Report: TAB REPORT
Function: Test, Adjust, & Balance
Date: 06/26/2023

PROJECT
06-19-23 CULVERS - COLUMBUS, GA

Issue List

HVAC DUCT PLAN

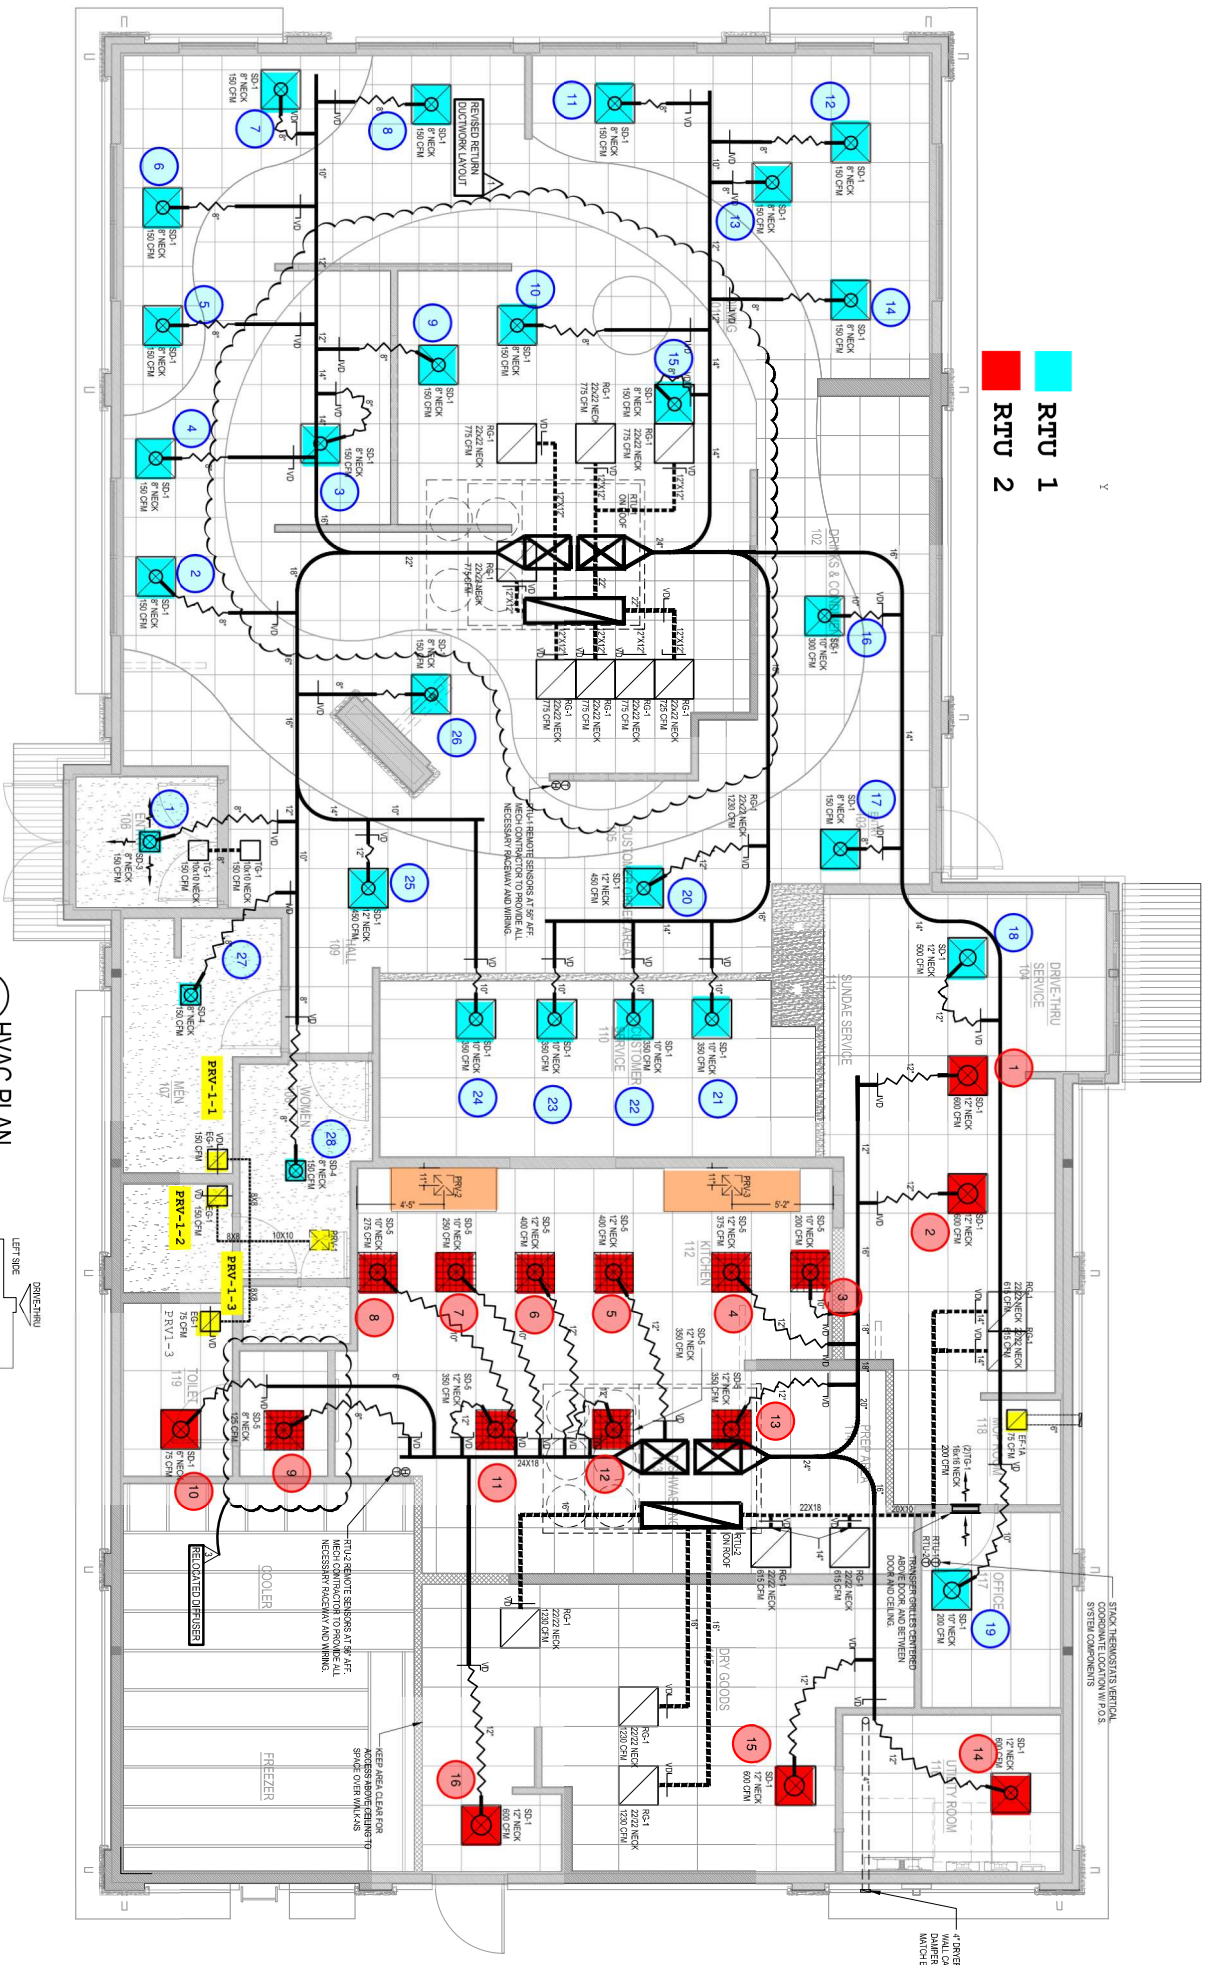
Issue Name : OFFICE DIFFUSER DUCTWORK
Description : OFFICE SUPPLY DIFFUSER IS DUCTED TO RTU2 INSTEAD OF RTU1. MSET M101 CALLS FOR THAT DIFFUSER TO BE DUCTED TO TO RTU1. PER MECHANICAL THE TRUSS WORK MAKES DUCTING TO RTU1 IMPOSSIBLE. THIS MAY LEAD TO UNCOMFORTABLE TEMPERATURES IN OFFICE AS THE KITCHEN CALLS HAS A DEMAND FOR COOLING WIEN THE OFFICE IS ALREADY COLD.

Issue Name : RTU 1 LOW DIFFUSERS
Description : AS A RESULT OF INCORRECT DAMPERS BEING INSTALLED AND THE DUCTWORK LAYOUT DIFFERING FROM THAT SHOWN ON THE MSET THERE ARE 4 DIFFUSERS THAT ARE BELOW DESIGN. SEVERAL FULL PASSES WERE MADE TO ATTEMPT TO RESOLVE THIS BUT WERE UNSUCCESSFUL. SPACE IS COMFORTABLE AS IS.
Created By : National TAB **Assigned To :** National TAB - William Patton
Status : Open
Originated Date : 06/21/2023 - William Patton - National TAB

- **06/22/2023 National TAB - William Patton**
 - RECOMMENDED TO INSTALL VOLUME DAMPERS FOR THE DIFFUSERS AT THE TAKEOFFS. IT IS ALSO RECOMMENDED TO INSTALL BRANCH DAMPERS. NTAB WAS UNABLE TO SEE OR USE ANY BRANCH DAMPERS DUE TO SPRAY INSULATION ON THE DUCTWORK.
